ATTACHMENT 1

MARKED-UP EXISTING TECHNICAL SPECIFICATIONS

The following pages depict the changes proposed to the existing Technical Specifications.

Figure 3.7.17-1 (page 1 of 1)
MINIMUM REQUIRED FUEL ASSEMBLY BURNUP AS A FUNCTION OF
INITIAL ENRICHMENT TO PERMIT STORAGE IN REGIONS 2-AND-3

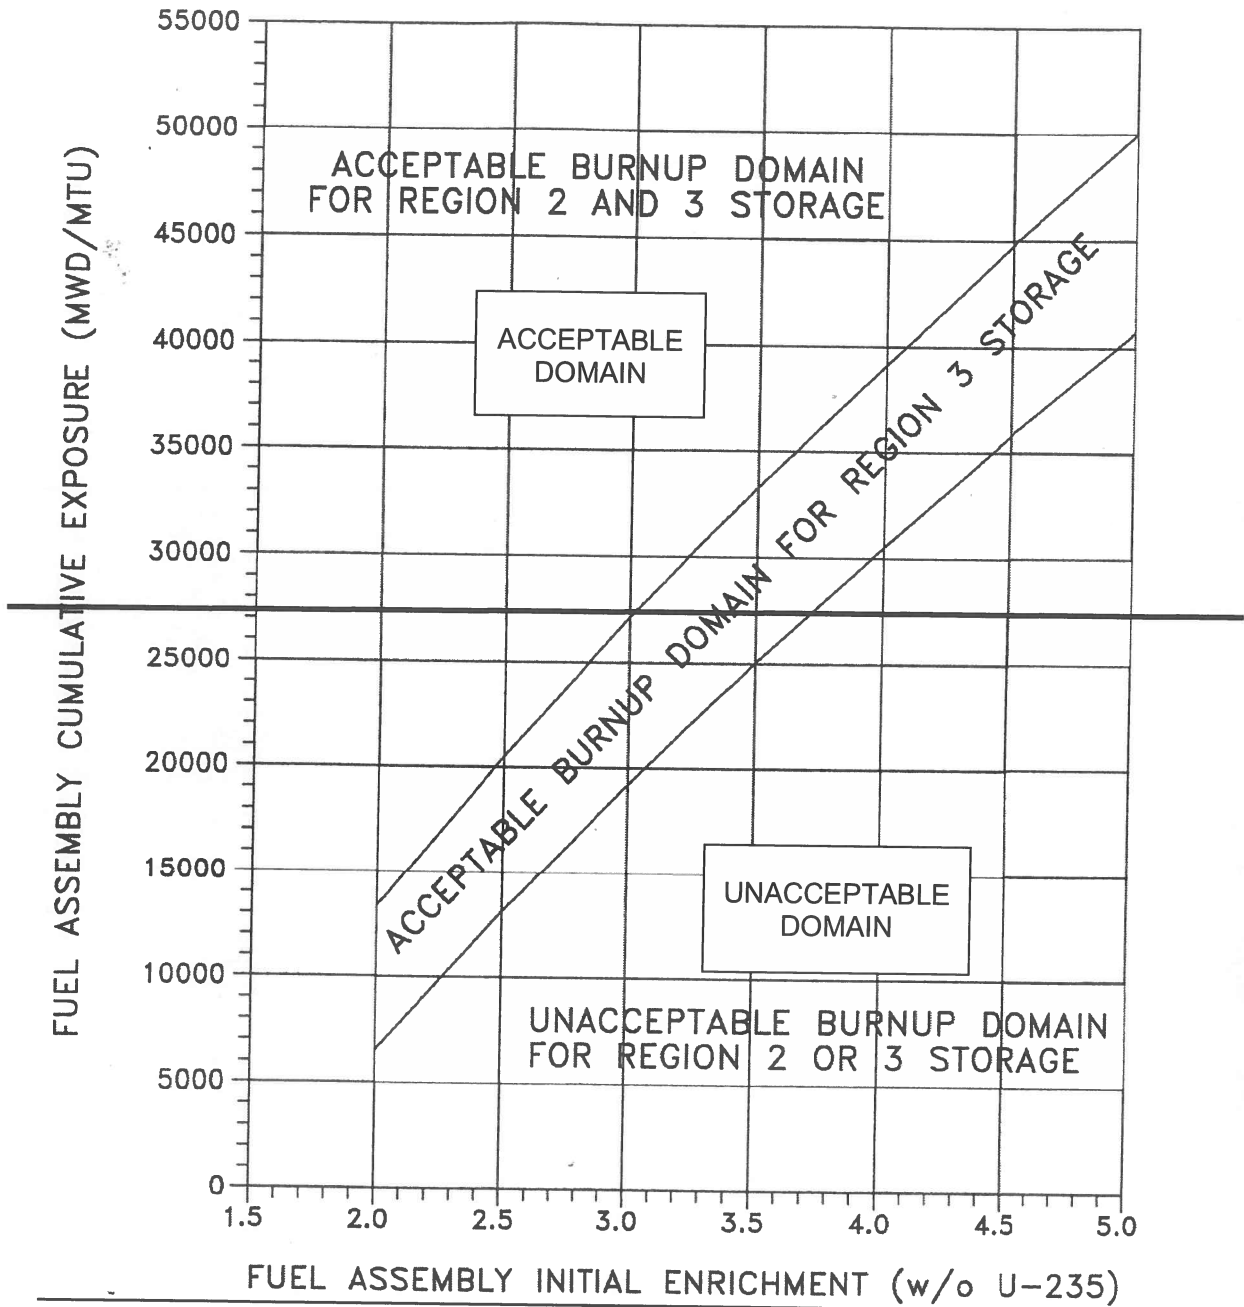
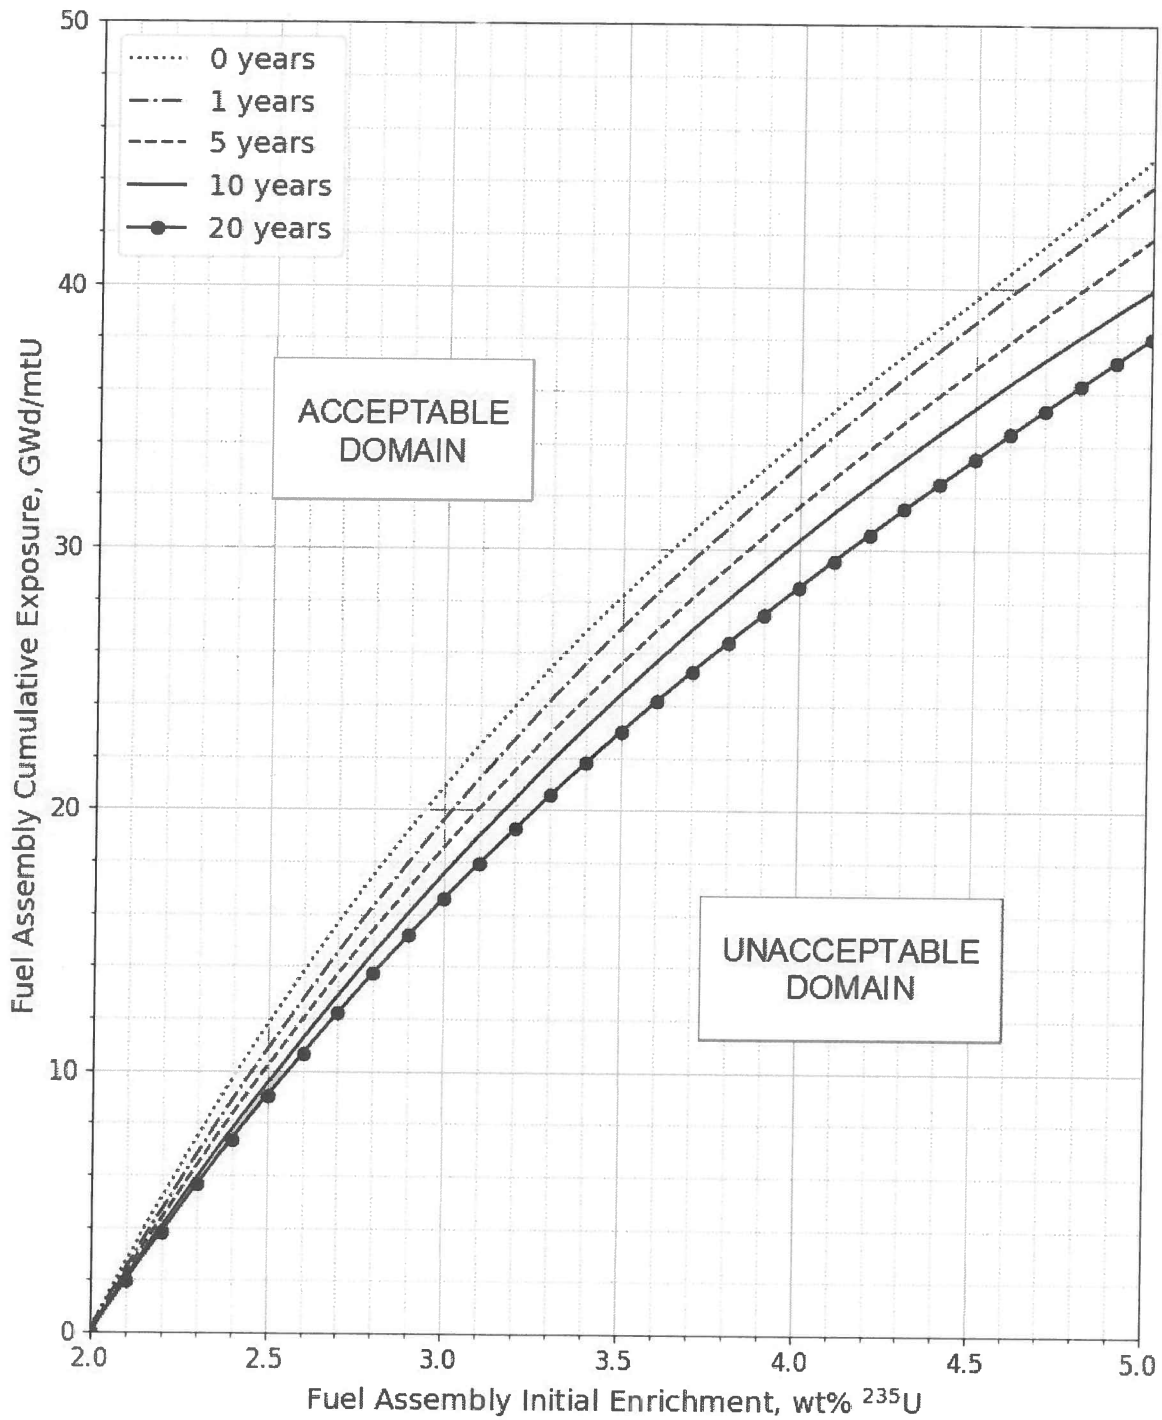
LCO 3.7.17 The combination of initial enrichment and burnup of each spent fuel assembly stored in Region 2 or 3 shall be within the Acceptable Domain of Figure 3.7.17-1 or in accordance with Specification 4.3.1.4.

SURVEILLANCE	FREQUENCY
SR 3.7.17.1 Verify by administrative means the initial enrichment and burnup of the fuel assembly is in accordance with Figure 3.7.17-1 or Specification 4.3.1.4.	Prior to storing the fuel assembly in Region 2 or 3

- c. A nominal 8.99 inch center to center distance between fuel assemblies placed in the fuel storage racks;
- d. Partially spent fuel assemblies with a discharge burnup in the "Acceptable Burnup Domain" for Region 2 ~~and 3-storage~~ of Figure 3.7.17-1 may be allowed unrestricted storage in the fuel storage racks, except for the empty cells in the checkerboarding configuration (Region 1);

- e. ~~Partially spent fuel assemblies with a discharge burnup in the "Acceptable Burnup Domain for Region 3 Storage" of Figure 3.7.17-1 may be allowed unrestricted storage, except for the empty cells in the checkerboarding configuration, and except in Region 2 locations in a Mixed Zone Three Region configuration in the fuel storage racks; and~~

- f. New or partially spent fuel assemblies with a discharging burnup in the "Unacceptable Burnup Domain" for Region 2 ~~or 3-Storage~~ of Figure 3.7.17-1 will be stored in Region 1.
